ADS-B MASPS (DO-242A Draft) COMMENTS
RTCA SC-186

#	Author	Section	Page	Comment	Suggested Resolution
1	WG-6	3.2.3.1	75-77	IP46 – Include changes to text from 3.2.3.1 and Table 3-1.	See Attachment WG6-1 for needed changes to 3.2.3.1 and Table 3-1 which address IP46. WG6 Response: Agreed. Accepted. / Done.
2	WG-6	M.3		IP47 – Addition of proposed M.3 not included in draft.	See Attachment WG6-2 for new section to Appendix M. WG6 Response: Editorial / Agreed. Accepted. / Done.
3	WG-6	2.1.2.6	31	The resolution for IP54 was not included in the draft DO-242A. The paragraph in 2.1.2.6 which states the new requirement that the pilot shall have the ability to inhibit the broadcast of altitude if it is deemed invalid by ATC or the cockpit is missing.	See Attachment WG6-3 for section 2.1.2.6. (The needed paragraph to address IP54 is highlighted in yellow.) WG6 Response: Agreed. Accepted. / Done.
4	WG-6	3.3.3.1.2	89	<p>(Also see Jerry Anderson #20, Ron Jones #20, Tony Warren #9, UPS-AT #29, and Lincoln Laboratory #1-d.)</p> <p>In §3.3.3.1.2 the word “twice” needs to be deleted from the sentence regarding the potential 5% that do not meet the 95% acquisition range requirement.</p> <p>WG6 Response

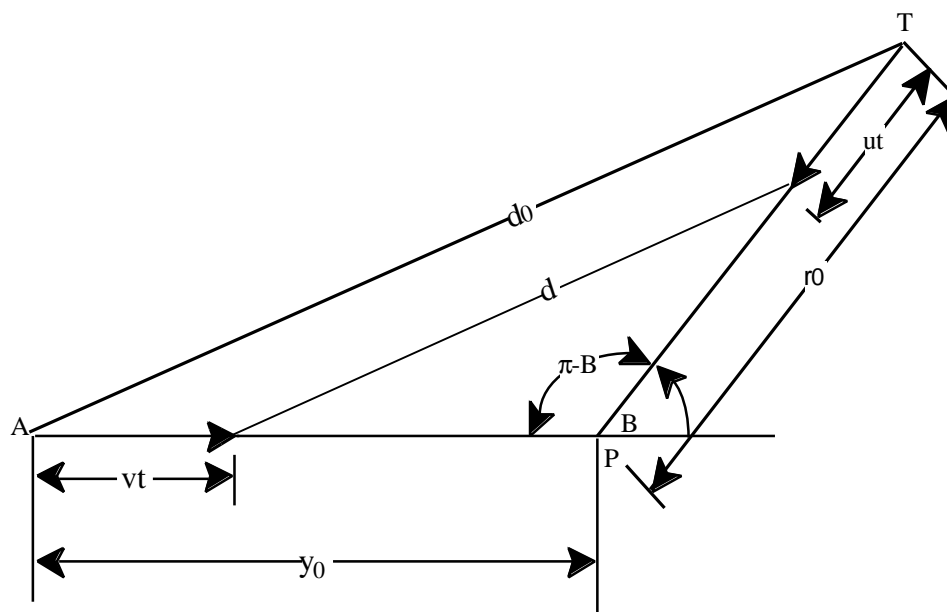
The revised Note 3 for Table 3-4(a) incorrectly interprets the range requirement from Appendix H. Rather the 64 NM range requirement applies to targets at +/- 45 degree from forward and not from port or starboard (i.e., +/- 90 degrees from forward) bearing angles. Furthermore, there is no basis presented in Appendix H to justify the increase in aft range to the 48 NM value in the new Note 3 to table 3-4(a).

The intent of expressing the range requirements relative to target bearing is to provide a constant 4.5 minute acquisition range for encounters where the target aircraft is approaching from various bearing angles. The maximum aircraft velocity is set at 600 knots (Appendix H) thus the maximum distance either own aircraft or target aircraft can travel in 4.5 minutes is 45 NM. This leads to the 90 NM requirement from Table 3-4a being applicable to a head-on encounter.

Attachment WG3-1: Acquisition Ranges for Targets to the Side or Aft of Ownship

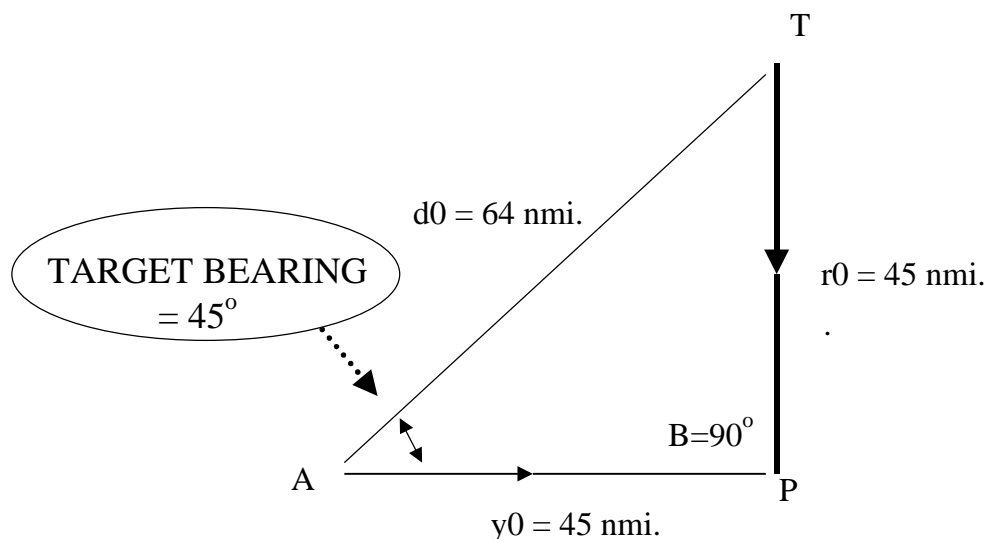
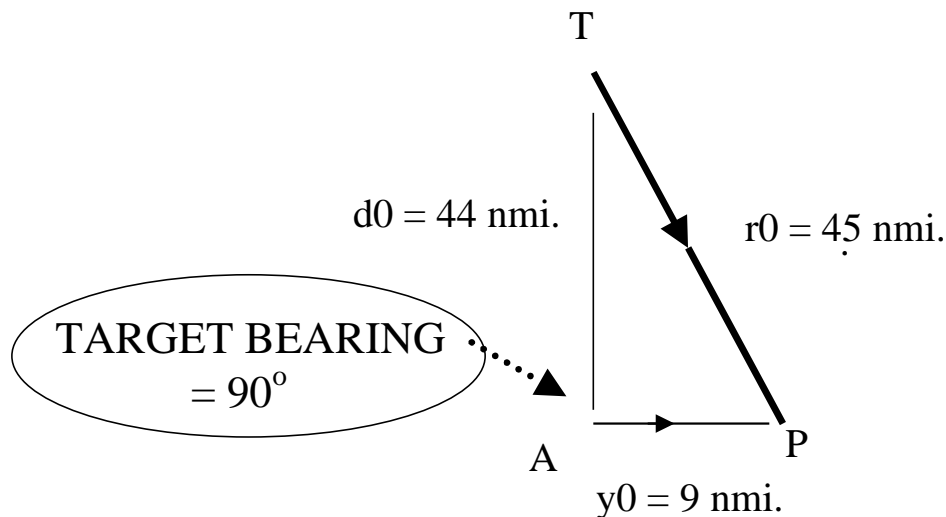
With angle $B=90$ degree for the crossing encounter this figure can be more accurately redrawn as follows:

Thus the 64 NM range requirement is not appropriate for a Port or Starboard target bearing encounter but rather for an encounter where the target aircraft is approaching at a bearing of 45 degrees from the forward direction.

The worst case for a true port or starboard target bearing encounter and where own aircraft is operating at the minimum velocity and where the target aircraft is approaching at the maximum velocity (i.e., 600 knots). The current DO-242 Appendix H analysis used a minimum aircraft velocity of 300 knots in keeping with high altitude enroute/oceanic operations. The revised Appendix H of DO-242A has changed the minimum aircraft velocity to just 120 knots. While this low a velocity may be unrealistic for high altitude operations, even such a low value would result in the following maximum port and starboard air-to-air range requirement.

Thus in this worst case Port or Starboard encounter (requiring maximum air-to-air acquisition range) own aircraft (A) has a velocity of 120 knots and the target aircraft (T) has a velocity of 600 knots, the required range is 44 nmi. in order to provide target tracking for 4.5 minutes before point of closest approach.

Figure 1. Two Possible ADS-B Position Reference Points.

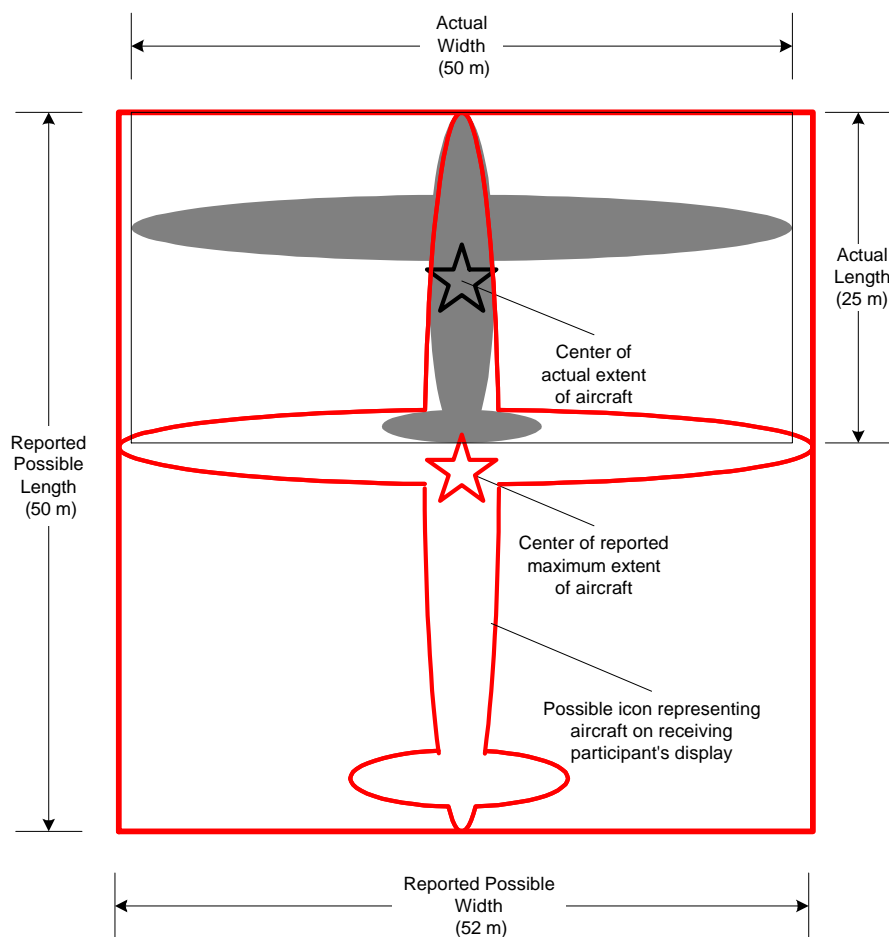
Also, an aircraft’s ADS-B position reference point is presently defined as the center of the smallest rectangle that circumscribes the aircraft’s horizontal extent and is oriented parallel to the aircraft’s heading. This may not be the optimum location for use with some applications. See Figure 1 below.

The figure shows the circumscribing rectangle for the powered glider of our example, and also the rectangle that bounds the maximum extent of that powered glider as reported in its aircraft length and width codes.

Figure 2.1.2.5: ADS-B Position Reference Point.

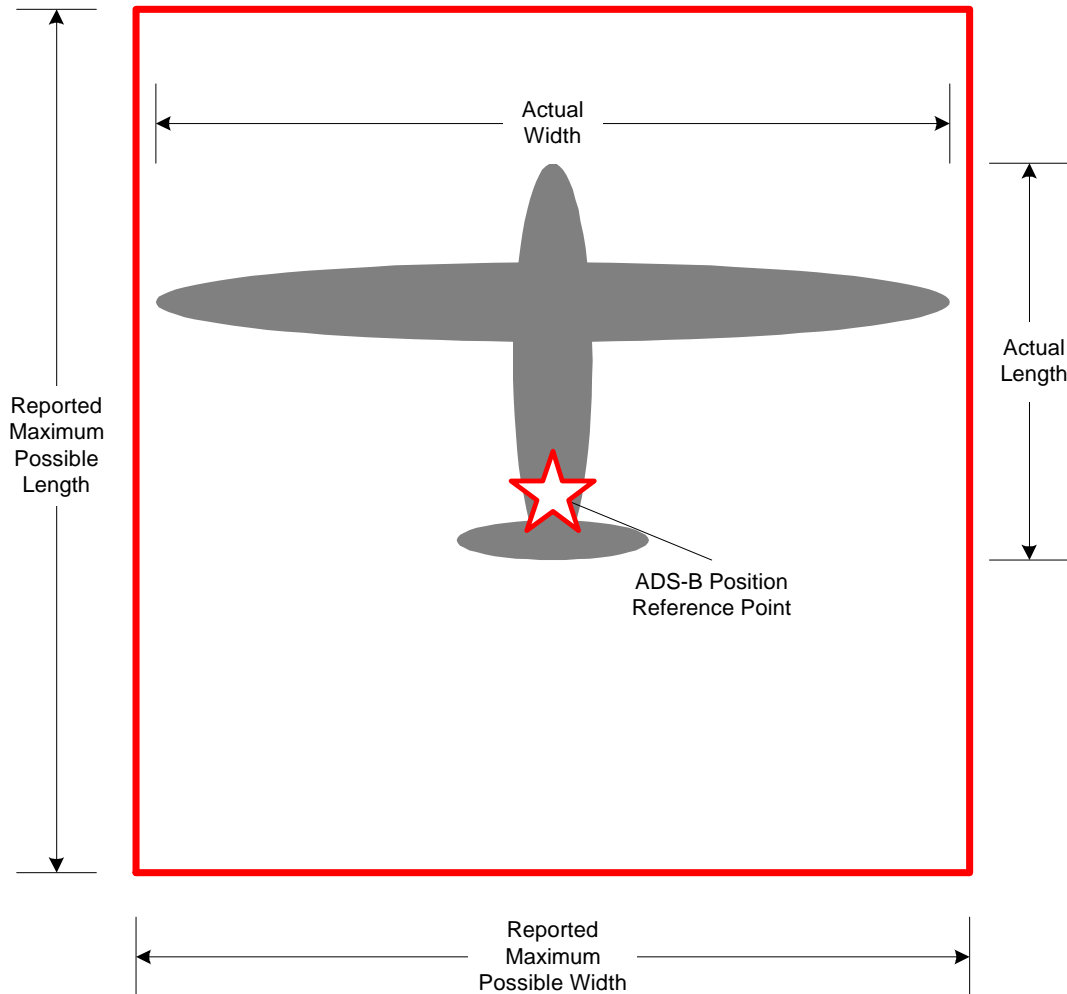
4	Tom Mosher, UPS AT	2.1.2.5	31	The <i>Note</i> under <u>Figure 2.1.2.5</u> is perhaps confusing because of the phrase “with respect to the body of the aircraft,” which might be construed to be “with respect to the fuselage.”	Delete the phrase “with respect to the body of the aircraft” from that note. WG6 Response: Editorial. Accepted. /Done.

Comparison Between Existing and Proposed Standards

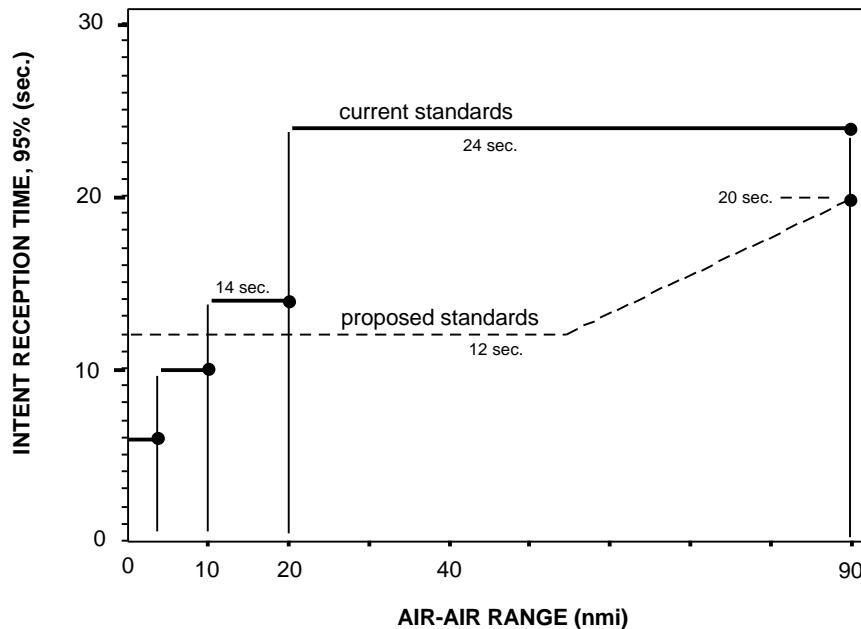
We have a serious concern about the proposed MASPS changes that would greatly increase the information transfer requirements for ADS-B. Although these would be major changes in minimum requirements, they are not based on actual applications of ADS-B and we do not concur that they are appropriate requirements to be included in a document that purports itself to be a minimum performance specification.

A comparison between proposed requirements for Intent communication and the current standards is shown below. We are struck by the fact that the proposal differs by a factor of 2 for all ranges between 20 nmi and 50 nmi. If adopted, it would double the communication data rate for Intent information. Such a very large change could, in our view, only be accepted if supported by a specific application, showing how the system performance would differ with and without the change.
